SERVICE - INFO

LuK Nr: 128 0055 11 – 280mm DBVR

Bulletin 988 2000 960

CASE IH, MANITOU, VOLVO**

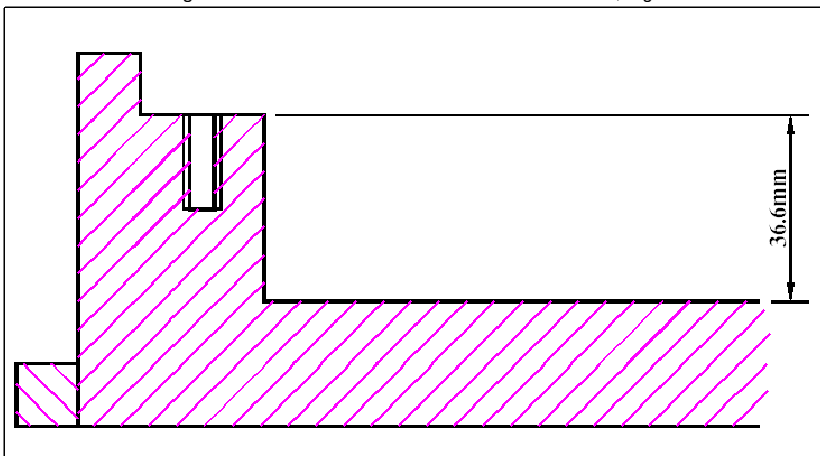
Info:	128 0055 11 replaces / ersetzt / remplace / sustituye a / sostituisce 128 0055 40 + 128 0055 41
(GB)	Please ensure that the flywheel is machined to a pot depth of 36.6mm.

(D)	Das Schwungrad ist auf eine Tiefe von 36.6mm auszdrehen,siehe unten.
(F)	Veuillez vous assurer que le volant-moteur est rectifié à une profondeur de 36.6mm.

(E)	Asegúrese de que el volante está mecanizado hasta una profundidad de 36.6mm.
(I)	Controllare che il volano venga rettificato a una profondità di 36.6mm.
LuK Repsets:	628 1032 07 = 128 0055 11 + 328 0175 42 + 500 1046 50 + 410 0026 00 628 1032 09 = 128 0055 11 + 328 0175 42 628 1033 07 = 128 0055 11 + 328 0175 41 + 500 1046 50 + 410 0026 00 628 1033 09 = 128 0055 11 + 328 0175 41 628 2590 07 = 128 0055 11 + 328 0175 40 + 500 1046 50 + 410 0026 00 628 2590 09 = 128 0055 11 + 328 0175 40 628 2592 07 = 128 0055 11 + 328 0175 10 + 500 1046 50 + 410 0026 00 628 2592 09 = 128 0055 11 + 328 0175 10
	128 0055 11 – 128 0055 12 + 434 0342 10
